DECISION NOTICE
AND
FINDING OF NO SIGNIFICANT IMPACT
MINE BREAKOUT PORTALS
NORTH FORK MEETINGHOUSE CANYON
FEDERAL COAL LEASE U-47979

ENVIRONMENTAL ASSESSMENT
MINE BREAKOUT PORTALS
NORTH FORK OF MEETINGHOUSE CANYON
FEDERAL COAL LEASE U-47979

Utah Power and Light Company (UP&L) has submitted to the Utah State Division of Oil, Gas and Mining a proposal for three breakout portals in the North Fork of Meetinghouse Canyon, see Maps 1 and 2. These portals are associated with UP&L's operation of the Deer Creek Mine and will provide ventilation to the mine. Coal mined from the Deer Creek Mine is from Federal Coal Lease U-47979 (see Map 2).

Map ● Revised locations of proposed breakout portals

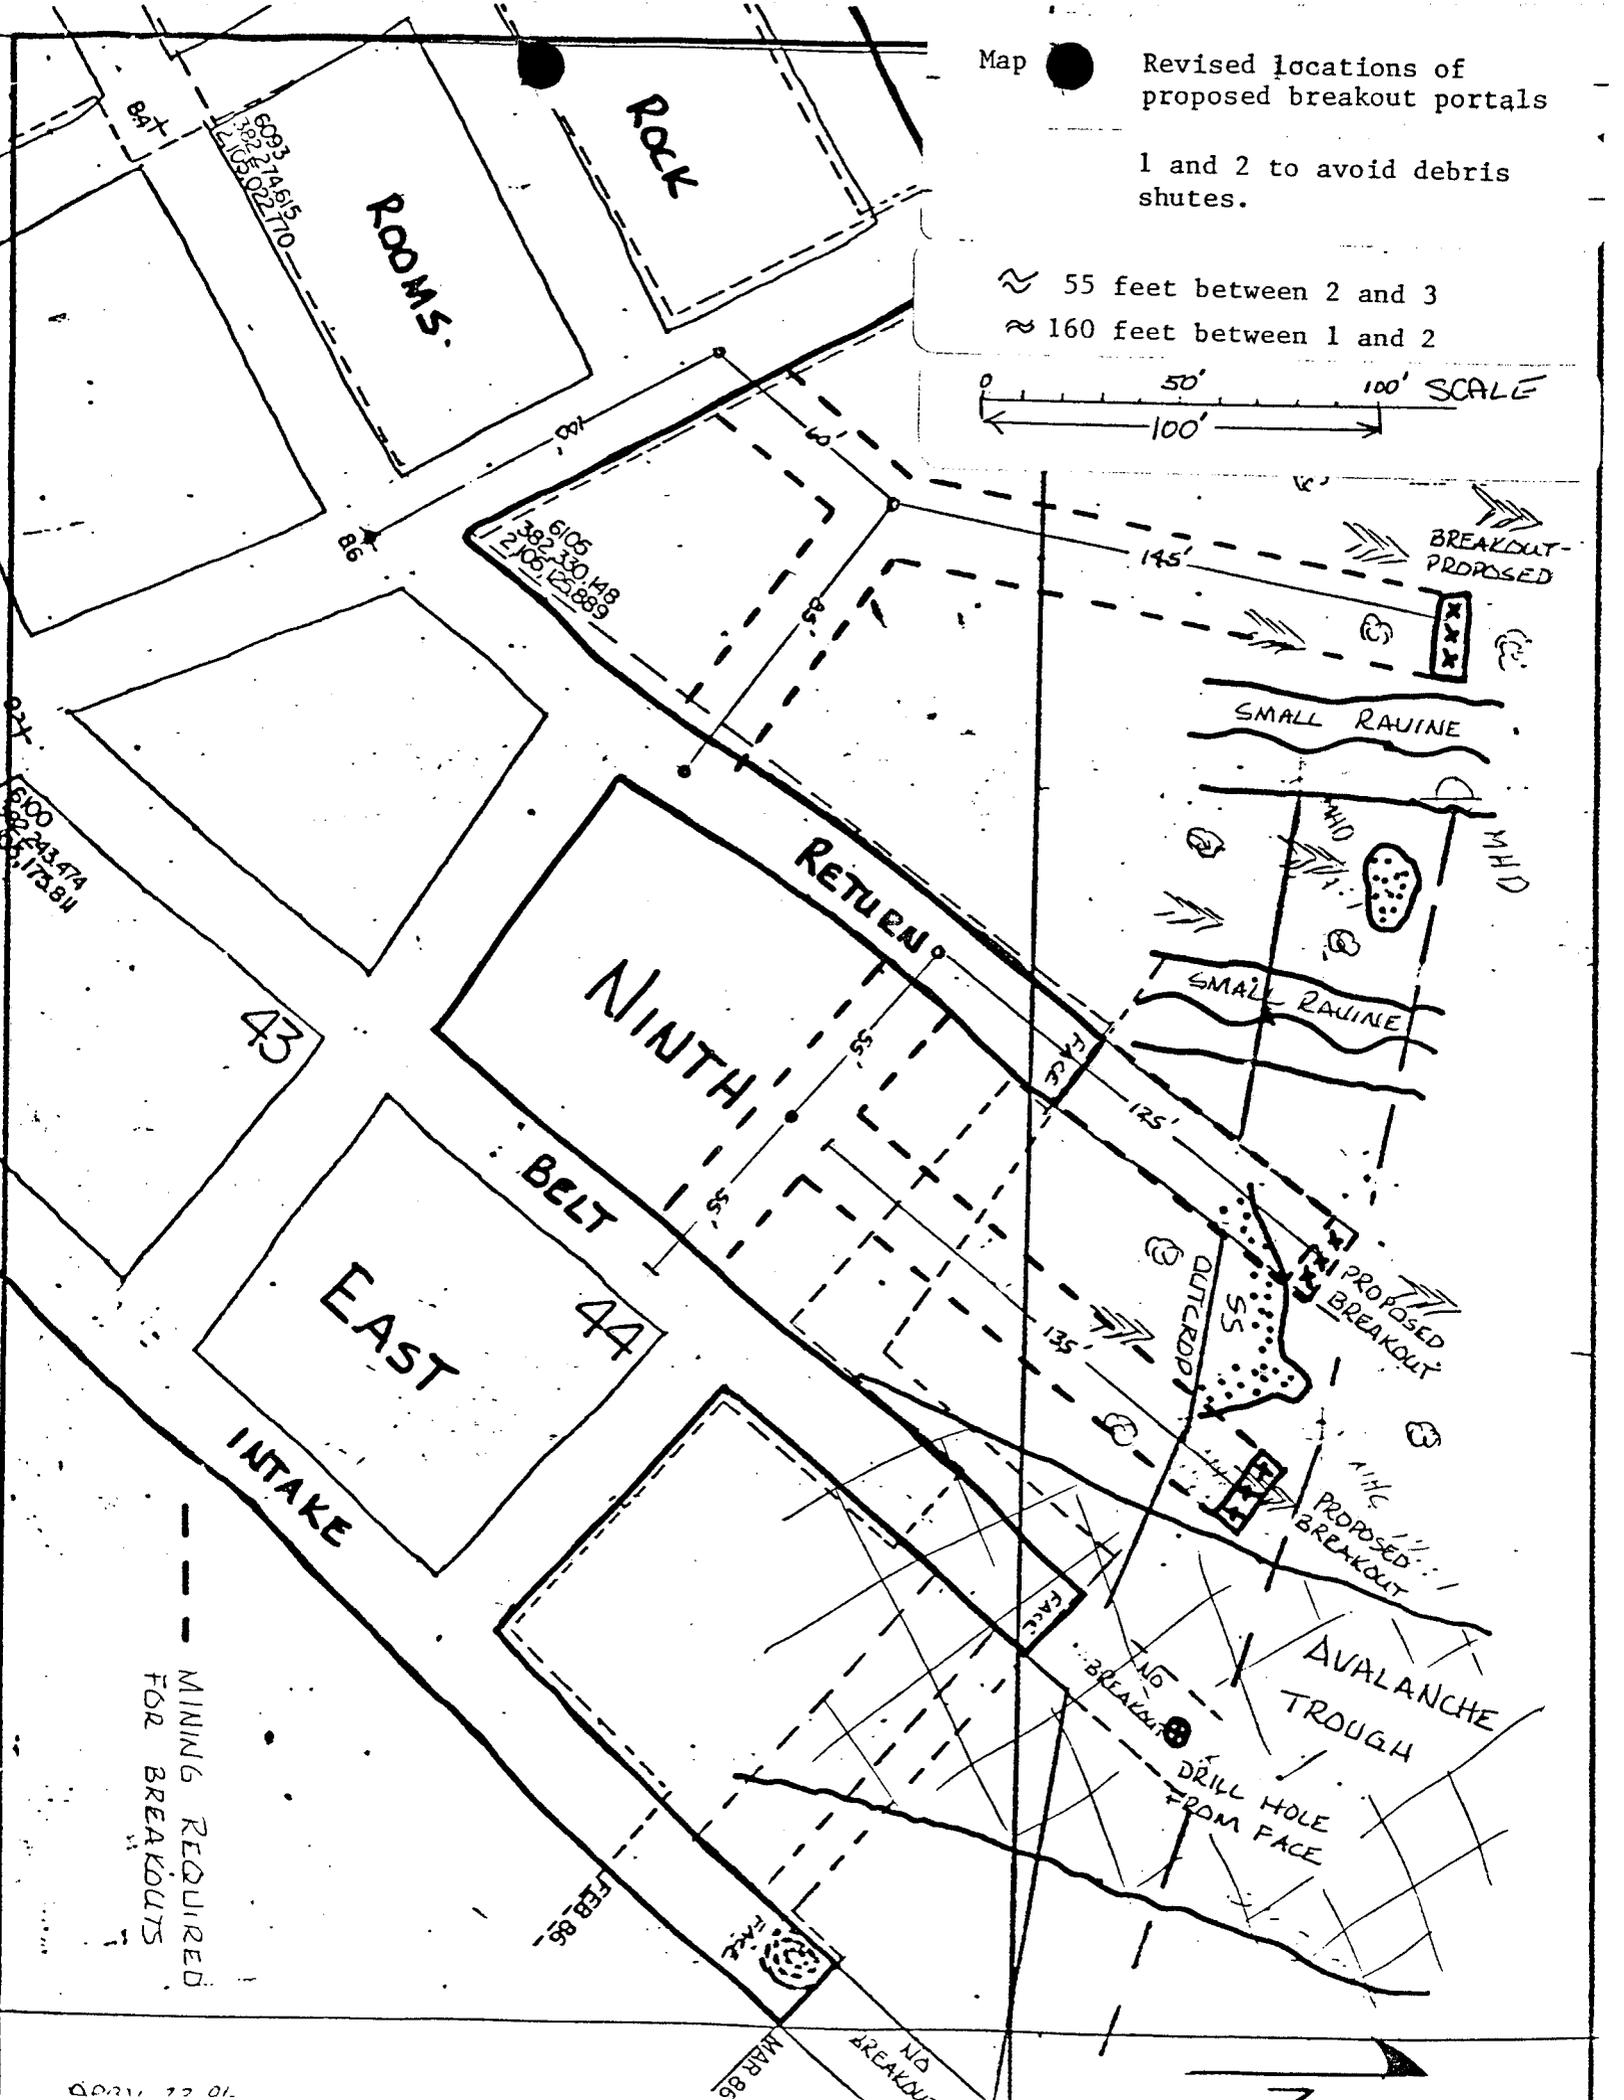
The site of the proposed breakout portals is on the eastern edge of the Wasatch Plateau escarpment. The area is typified by narrow canyons with steep to vertical side walls. The creek bottom in the North Fork of Meetinghouse Canyon near the project site is deeply eroded and barren of vegetation. On the south side of the canyon above the scour channel is a narrow bench with gentle slopes. The bench has a cover of conifers, brush and forbes. This cover extends up the steeper side slopes above the bench, until the slopes become very steep and vertical outcrop is encountered, about 50 feet. The project site is located on the edge of the upper extent of the large vegetation cover. The site is approximately 200 feet above the canyon bottom. On these steep side slopes, up to 100%, soils are thin and the ground is covered by scree type material. Several debris shutes exist along the slope. The middle breakout was located at the center of one of these debris shutes. UP&L was revised there proposal to avoid this area. The new locations are shown on Map #3.

1 and 2 to avoid debris shutes.
